Calvert Cliffs Nuclear Power Plant, Unit No. 1
Renewed Facility Operating License No. DPR-53
NRC Docket No. 50-317

Subject: Core Operating Limits Report for Unit 1, Cycle 23, Revision 1

**Calvert Cliffs Nuclear Power Plant
Core Operating Limits Report
COLR**

**Unit 1 Cycle 23
Revision 1**

U1C23 Refueling Boron Concentration Limits

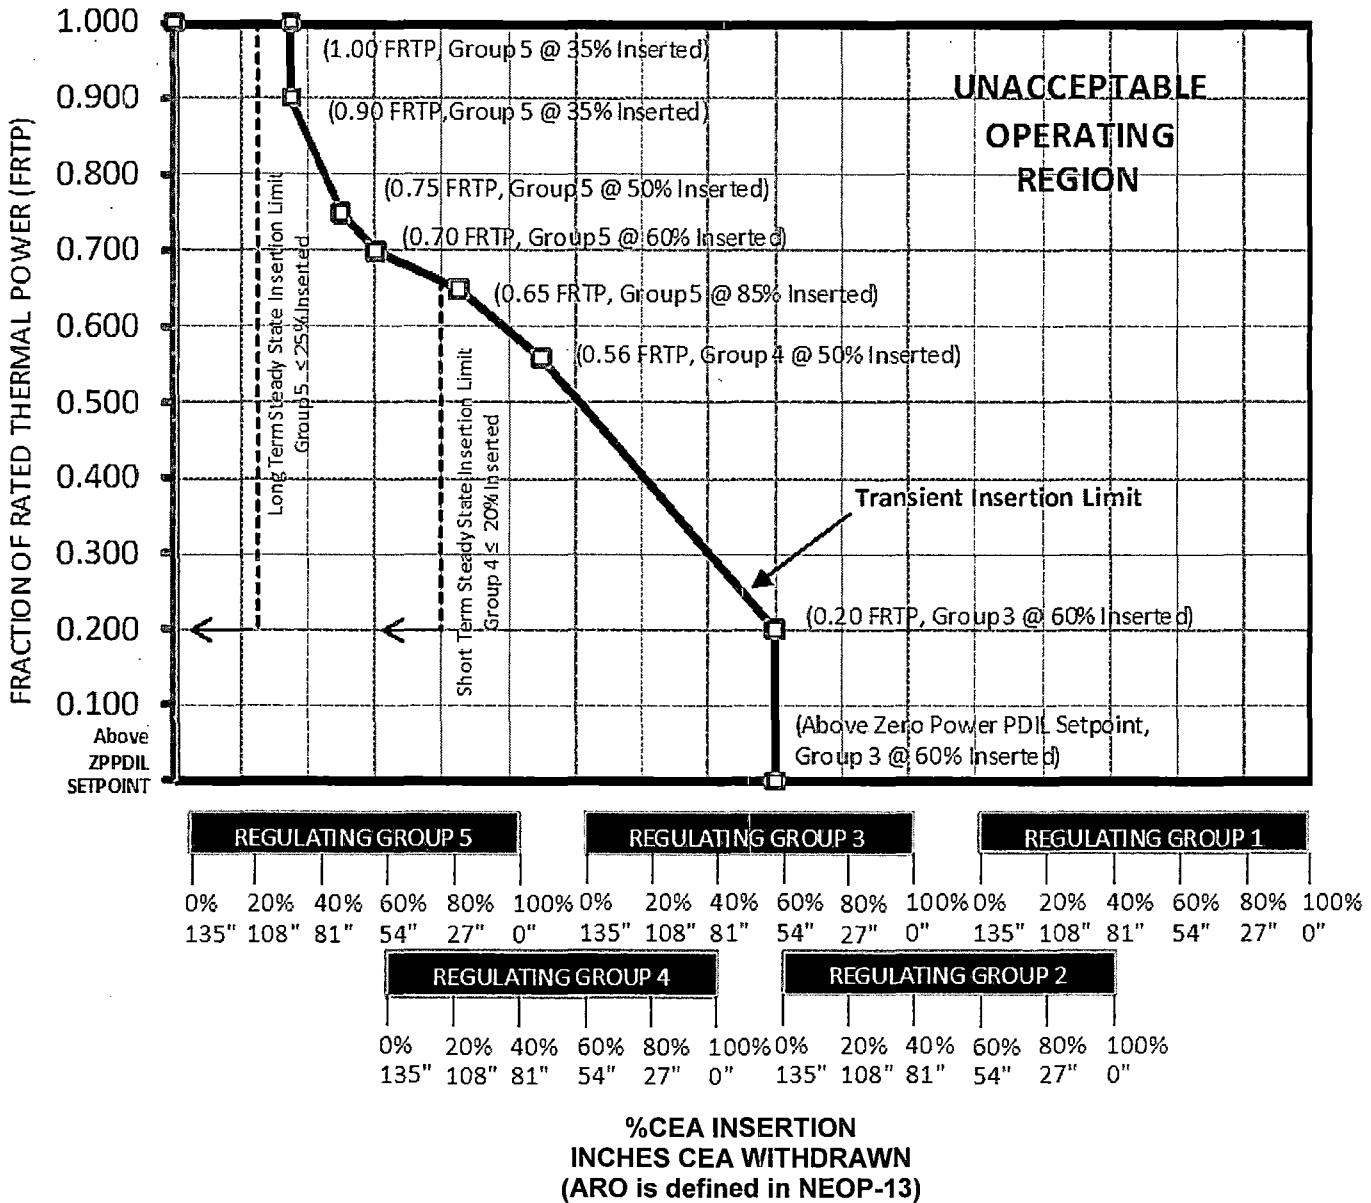
Added an end-of-cycle refueling boron concentration option per Safety Evaluation SE00553 Revision 0. This will allow the core to be offloaded to the spent fuel pool during the 2018 RFO and will allow the core to be borated to the boron concentration that will be required prior to loading the U1C24 core. This change is described in ECP-17-000593 Revision 0.

U1C23 Burnup ≥ 16 GWD/MTU
	0 Credited CEAs
Post-Refueling UGS or RV Head Lift Height Restrictions.	No Restriction
Minimum Required Refueling Boron Concentration: This number includes: <ul style="list-style-type: none"> ▪ Chemistry Sampling Uncertainty ▪ Boron-10 Depletion Allowance ▪ Margin for dilution of refueling pool between low and high level alarms ▪ Unlimited number of temporary rotations of fuel assemblies ▪ Extra Conservatism for empty locations during refueling operations. 	≥ 2560 ppm (Note 1)
